INITIAL FIRE SAFETY INSPECTION REPORT

Factory Name: Four H Fashions Ltd.

Date: 16-Feb-2021

Table-1: Building 01-Production building

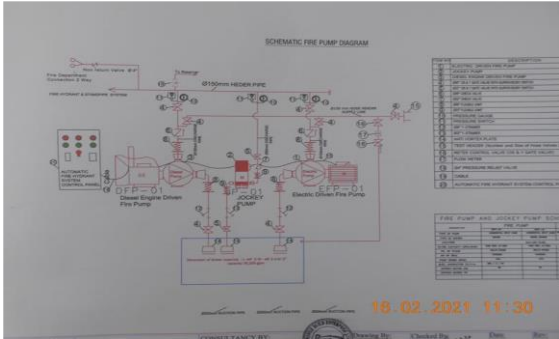
7	Fire rated construction	Unsealed penetrations and openings (i.e. bathroom plumbing pipes) are located on several locations (i.e. Fabric store and accessories store on ground floor) in the fire rated floor/ceiling assemblies.	Seal all penetrations and openings in floor/ceiling (full thickness of the floor/ceiling: minimum 2 hr.) assemblies by third-party certified fire rated materials to maintain the fire resistance rating. or Provide a minimum 2-hr fire rated shaft to separate the utility risers from each floor if required.	Within 3 months
---	-------------------------	--	--	-----------------
